ATCHAFALAYA SEDIMENT DELIVERY (AT-02)

**PROJECT COMPLETION REPORT
&
AS-BUILT DRAWINGS**

ENGINEERING CLOSURE REPORT
BIG ISLAND MINING (XAT-7)
AND
ATCHAFALAYA SEDIMENT DELIVERY (PAT-2)

ENGINEERING CLOSURE REPORT
BIG ISLAND MINING (XAT-7) AND ATCHAFALAYA
SEDIMENT DELIVERY (PAT-2) CWPPRA PROJECTS

PARTIAL PLAN
REVISION TO NATAL CHANNEL
(FIELD CHANGE NO. 2)

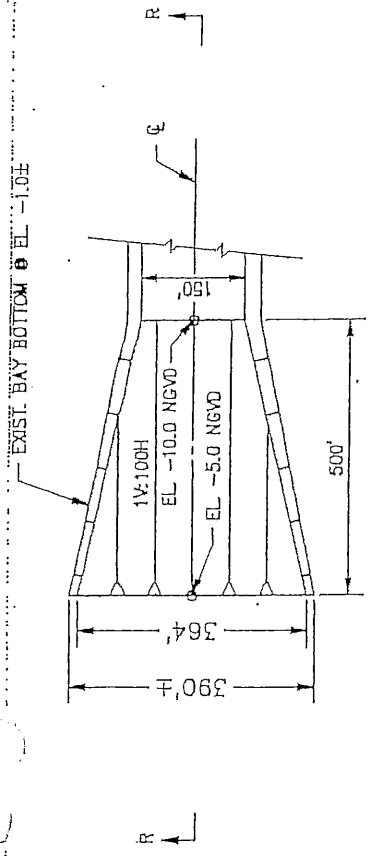
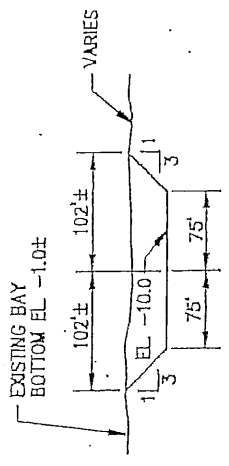
RE: BIM/ASD Project Field Change No. 2
Revision to Natal Channel Alignment Between Sta. 70+00 and End.
BCG Project 30594-1.

As the Engineer of Record and in accordance with the project specifications we are forwarding Field Change No. 2 to you for implementation into the project. This change calls for extending and revising the bottom width of Natal Channel from station 74+00 to the new end station 88+00. Also, adding Branch A channel at station 70+00 with a deflection angle of 45° and extending for 1500 feet in an effort to reach deeper bay bottoms. The new channel bottom width between Sta 74+00 and end, and the Branch A channel between Sta 0+00A and end is reduced to a 150 foot bottom at a design depth of -10.00 NGVD. The channel side slopes remain at IV:3H. In addition, there is a flair end transition on both channels as shown on the enclosed Field Change No. 2 drawing dated March 10, 1998. This change in cross section and channel extension is estimated to require the total dredging in Natal Channel of approximately 657,000 cubic yards; and is to be constructed at the unit bid price of \$1.50 per cubic yard. This change results in no changes to the contract unit prices and stays within the estimated bid quantity item no. 510 of the contract.

WIGHAM AND GANNUCH
CHANGE NO. 3
CHANNEL D AND REVISIONS
DA-4 AND DA-5

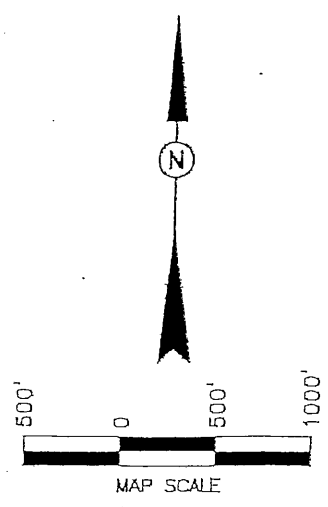
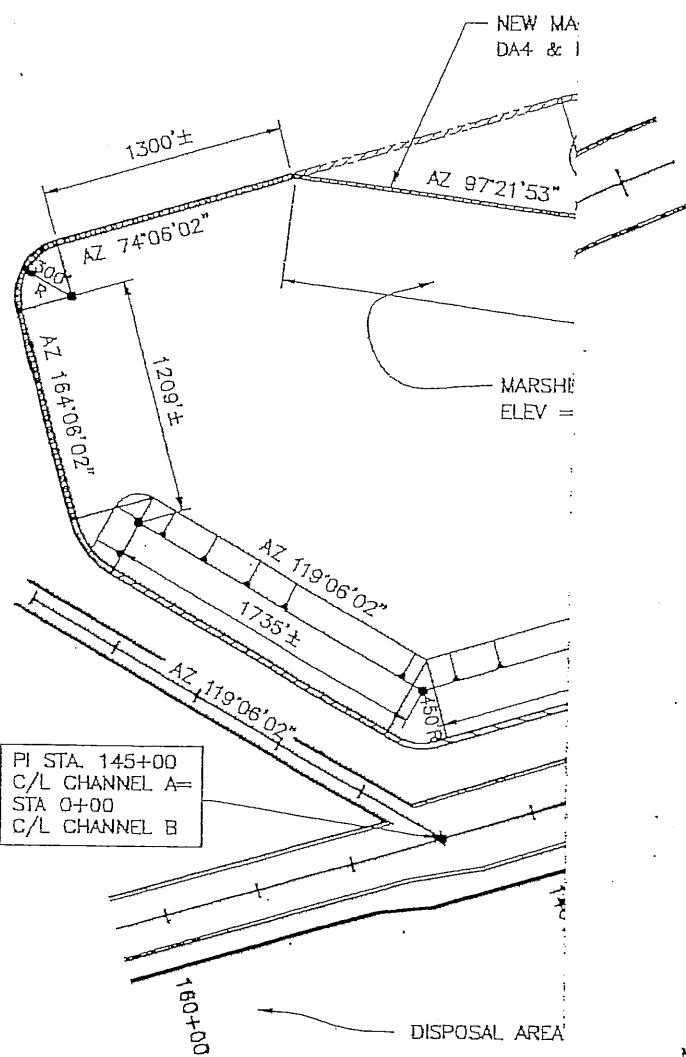
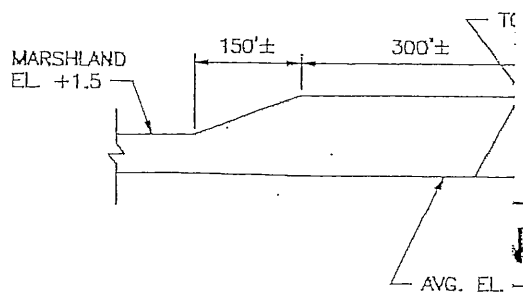
RE: BIM/ASD Project Field Change No. 3
Revise Channel D Alignment,
Delete Disposal Area No. 3
And Revise Disposal Area No. 4/5

1. Realigning the originally configured Channel D of the construction plans, to begin work at Channel A c/l station 67+20 and construct a 200' bottom to Elev. -10.0 NGVD. The new Channel D extends along a centerline as azimuth of 97° 21' 53" for 4000 feet, ending work at Channel D (c/l station 40+00).

2. Delete Disposal Area No. 3 from the project in its entirety.
3. Modify Disposal Area 4/5 to be contiguous to the new Channel D alignment, all as shown on "Field Change Drawing No. 3", dated June 1998 (copy attached).

5. Disposal Area 4/5 is revised and expanded along its perimeter to be contiguous to the new Channel D alignment, the optional back dike alignment for DA No. 4/5 has been shifted to follow the -1.0 NGVD contour elevation of the bay bottom. Some field deviation from alignment shown may be required to stay in shallow water (-1.0 NGVD).

<u>Item</u>	<u>Original</u>	<u>Revised</u>	<u>Change</u>
1.	Channel D:	101,000 cy	174,345 cy	+73,345
2.	DA No. 3:	+82.6 ac	0.0	-82.6 ac
3.	DA No. 4:	+92.68 ac	+91.1 ac	-1.6 ac
4.	DA No. 5:	260 ac	219 ac	-41.0 ac

BROWN, CUNNINGHAM AND GANNUCH
 FIELD CHANGE NO. 4 - DRAWING NO. 1
 OVERALL VIEW - REVISION TO WIDTHS OF CHANNELS A, B, C, E AND NEW CHANNEL F

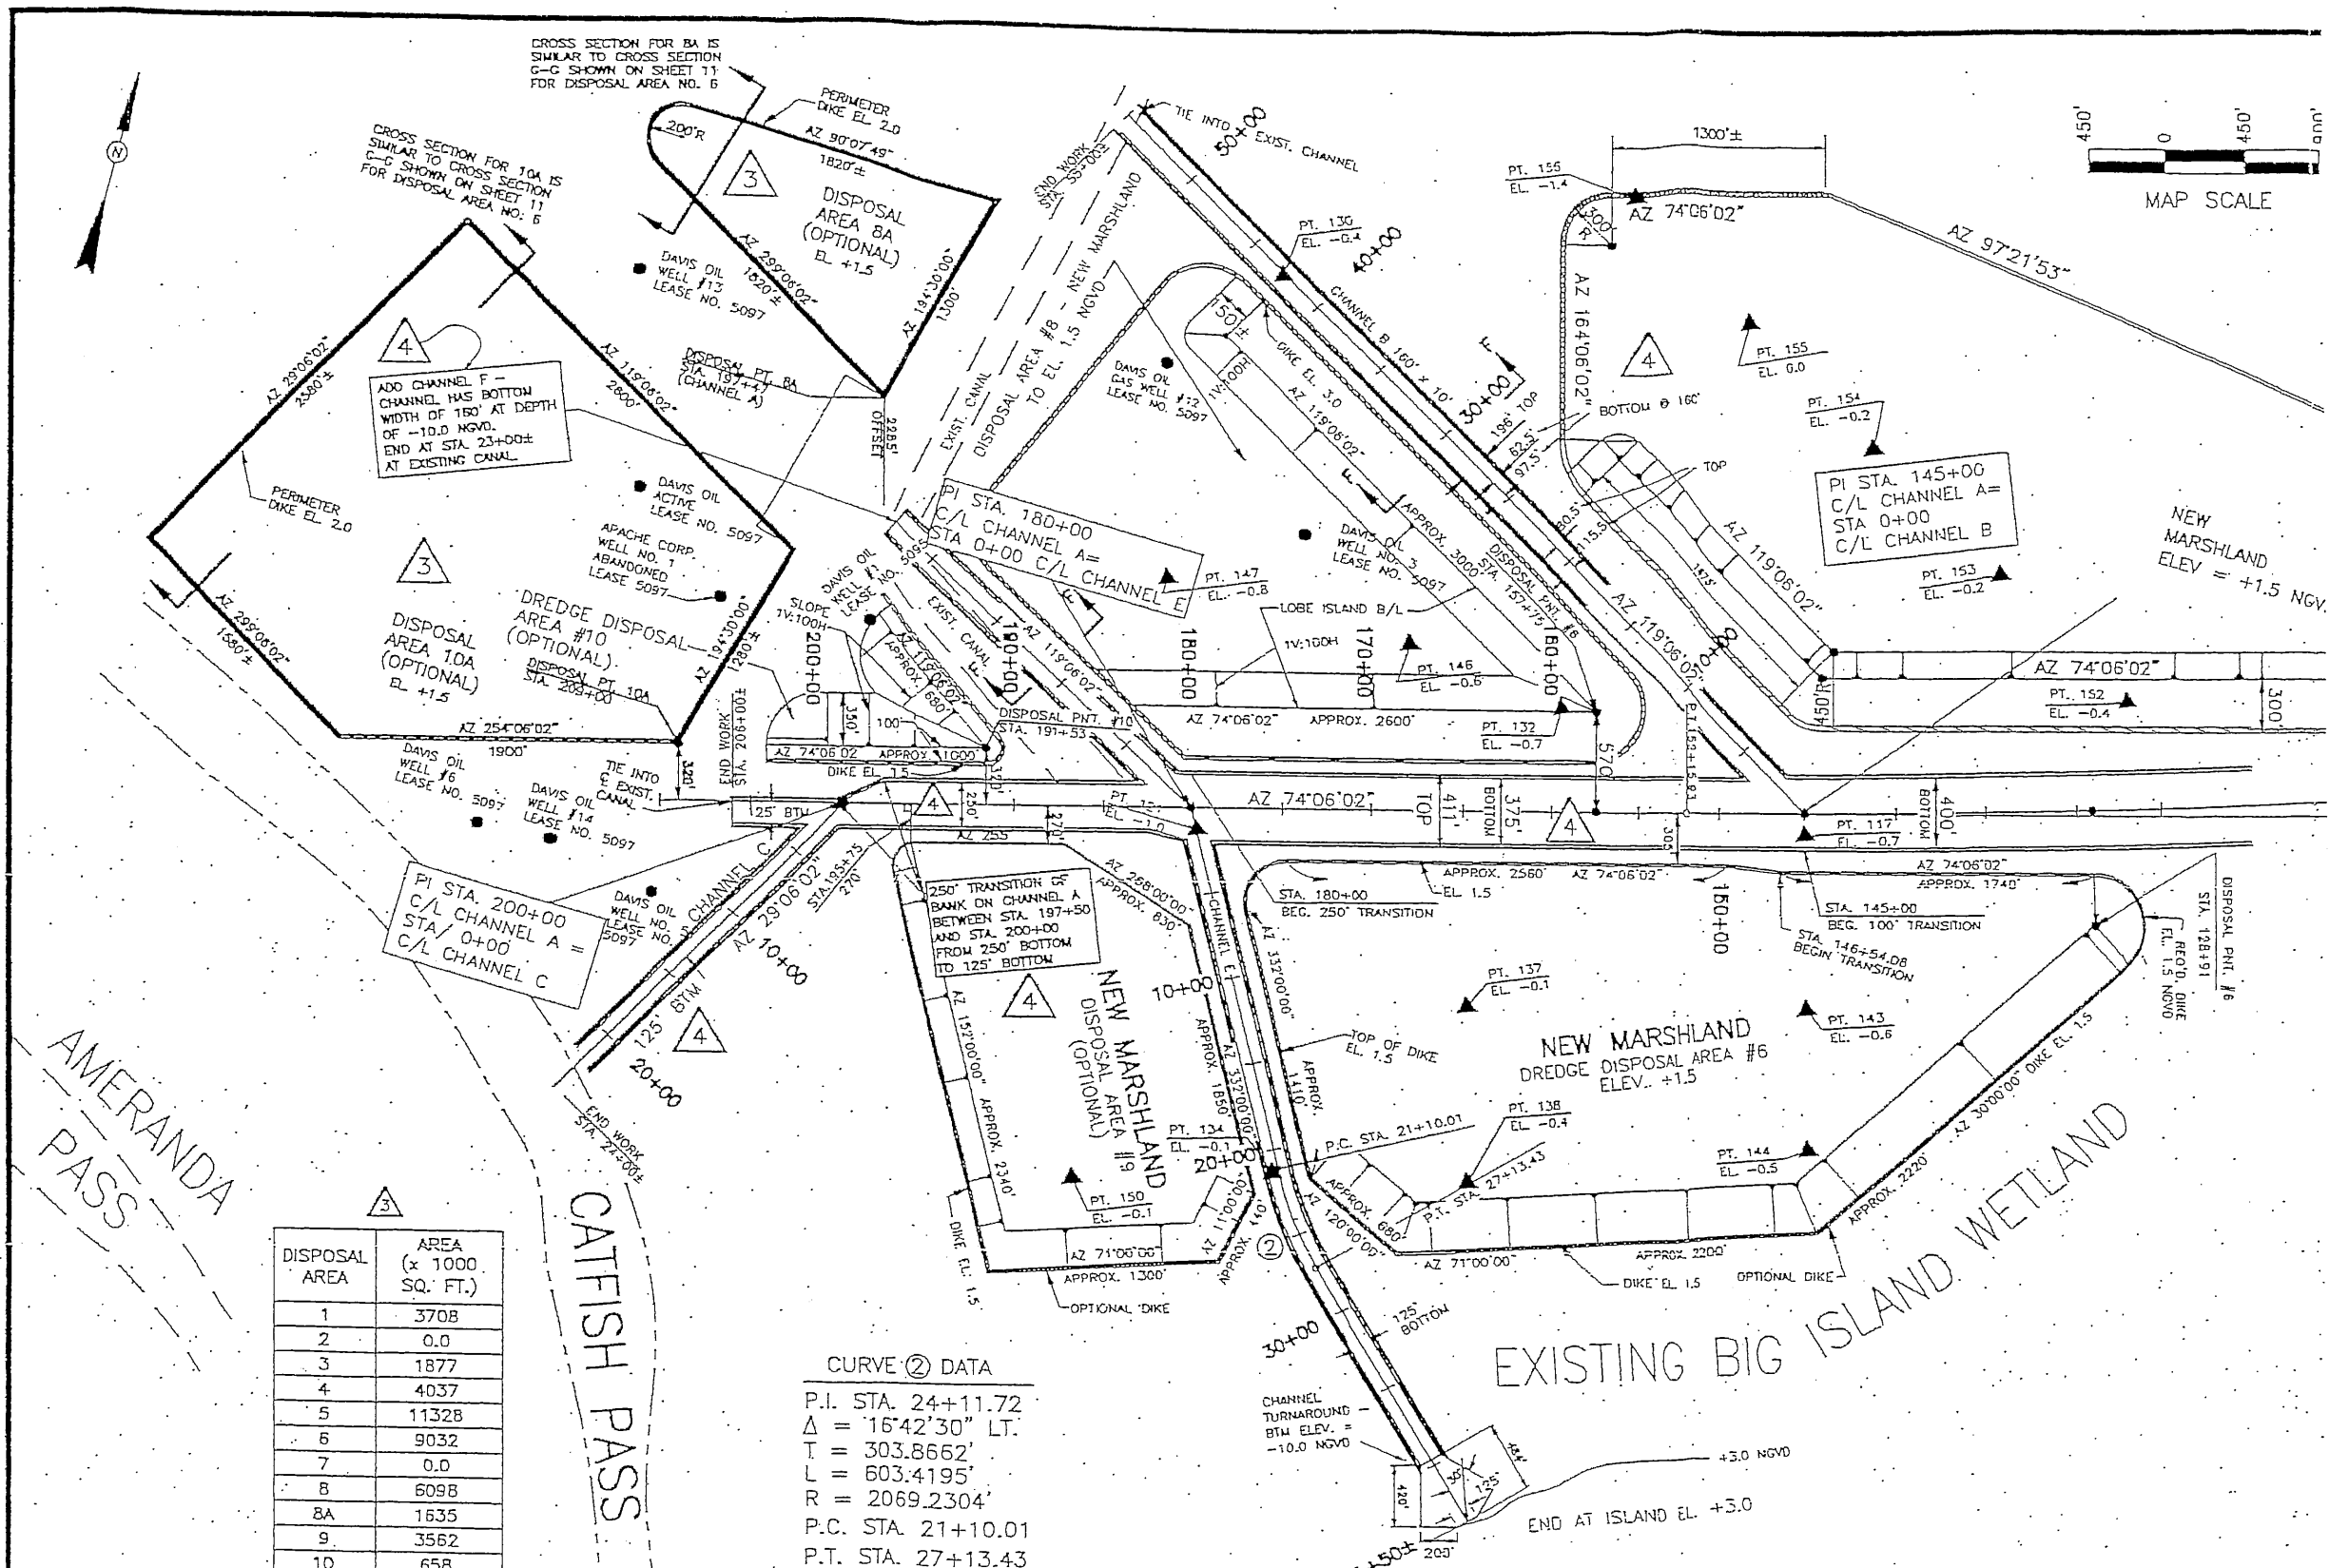
Re: BIM/ASD Project Field Change No. 4
Revised Channel Widths For "A", "B", "C", and "E" and add Channel F.

This letter shall confirm our discussions on completing the Big Island Mining project based upon the actual "Before Dredging Surveys", recently completed. In an effort to achieve the original design intent of this project and to maximize creation of marshlands acres we direct you to revise the following channels:

In addition, add new Channel F starting at station 180+00 of Channel A and extending on an azimuth of 119° 06' 02" to station 22+00± to intersect with the existing pipeline canal. Channel F shall have a bottom width of 160 feet to -10.0 NGVD. Also, extend the Disposal Area No. 8 dike along new Channel F with the bucket dredge to station 20+00 of Channel F. Contractor shall conduct a magnetometer survey prior to doing work along Channel F to insure that no pipelines exist.

BROWN, CUNNINGHAM AND GANNUCH			
FIELD CHANGE NO. 4 - DRAWING NO. 3			
REVISION TO WIDTH OF CHANNEL A - STA. 145+00 TO STA. 206+00			
DATE: JUNE, 1998	DESIGNED: EJM	DRAWN: CDH/WC	SHEET: 3 OF 5
ACAD FILE: D:\JOBS1\30594BI&ASD\FIELDCHANGES\FDCHG4-3.DWG

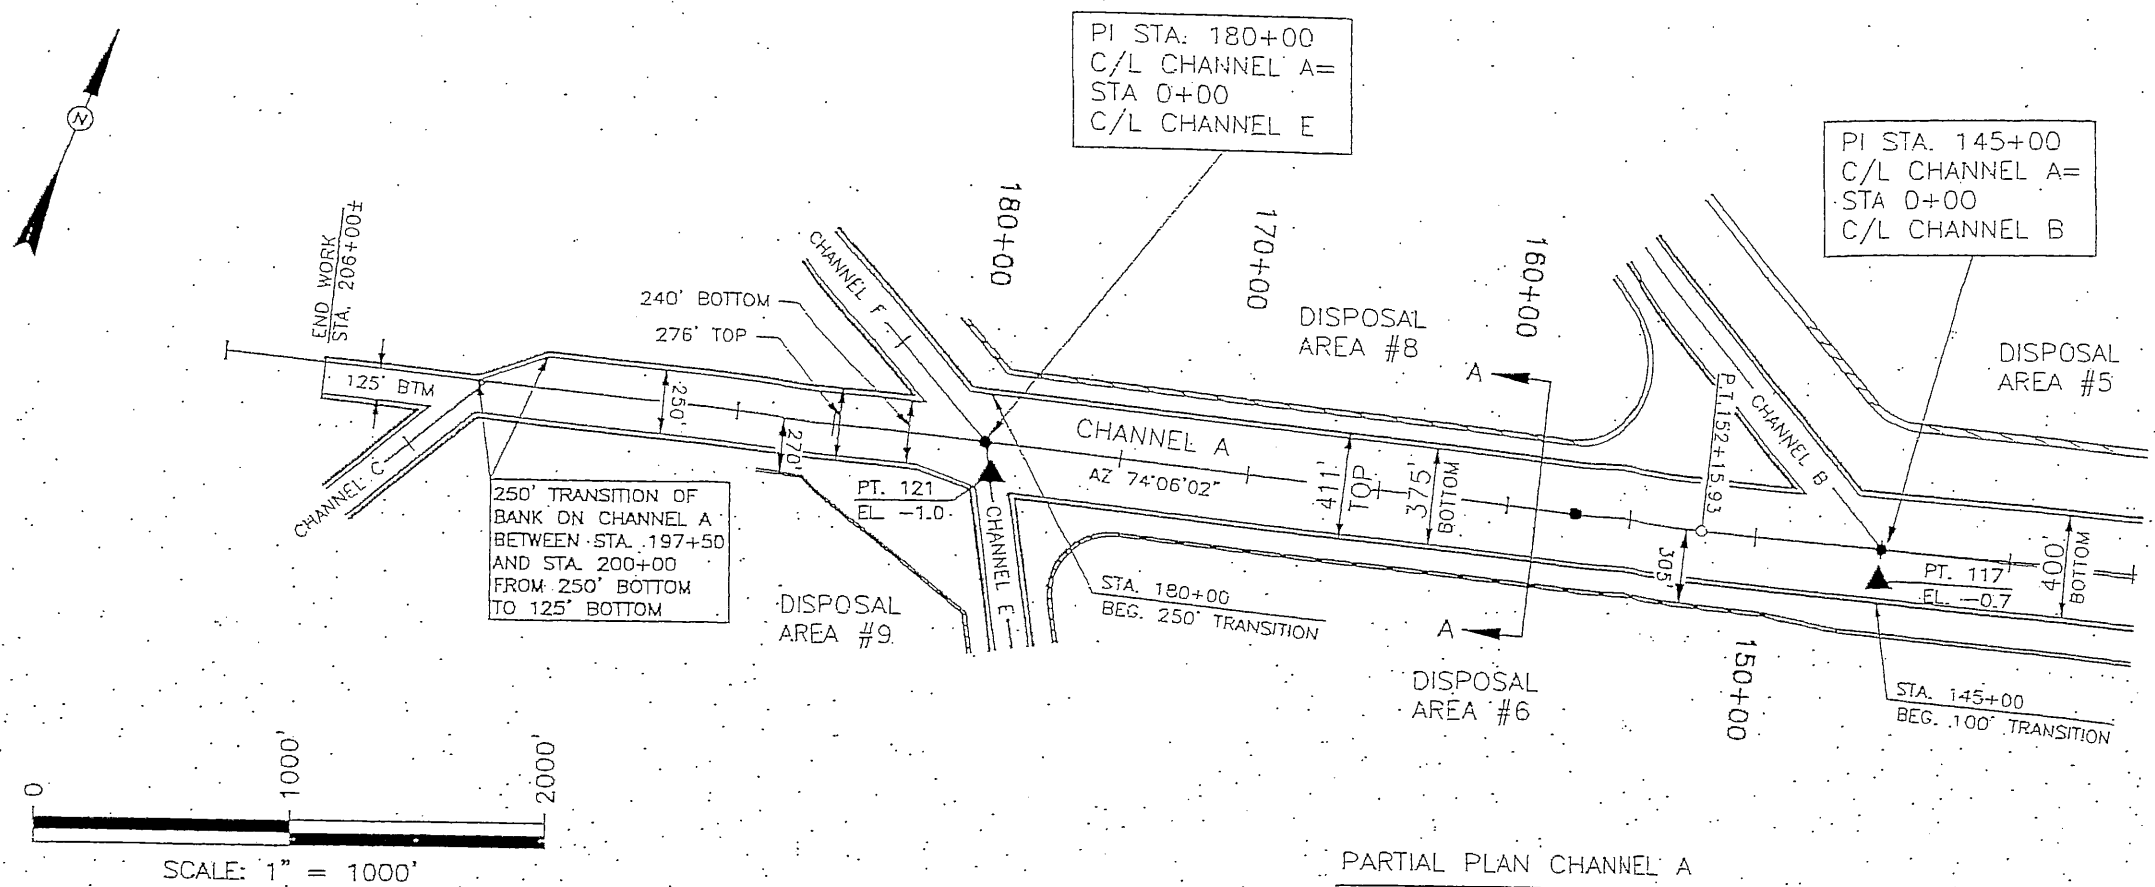
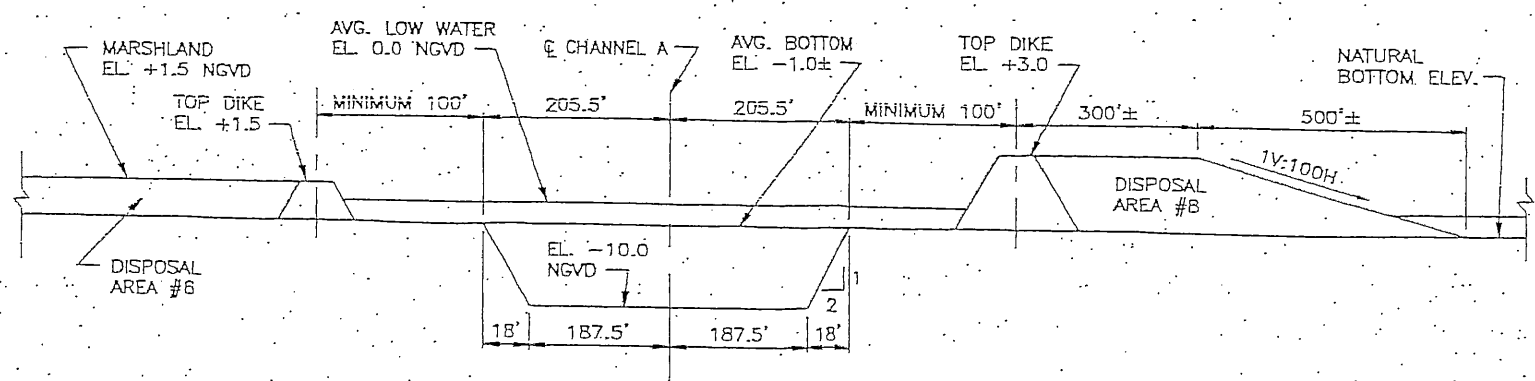
1. Channel A: Change the bottom widths as follows:
 - a. Widen bottom from 300' to 375' between station.145+00 and 180+00.
 - b. Bottom stays at 250' between station.180+00 and 200+00.
 - c. Shift 125' bottom Channel A to south side of channel baseline between station.200+00 and 206+00± (end of work).
2. Channel B: Widen bottom width from 125' to 160'.
3. Channel C: Widen bottom width from 100' to 125'.
4. Channel E: Widen bottom width from 100' to 125' and end work at station.41+50, to the +3.0NGVD contour line of Big Island.
5. Add a new Channel F with a bottom width of 160', starting at Channel A station.180+00 and extending on 45° to the north west for a distance of 2200 linear feet to tie-in with the existing pipeline canal.
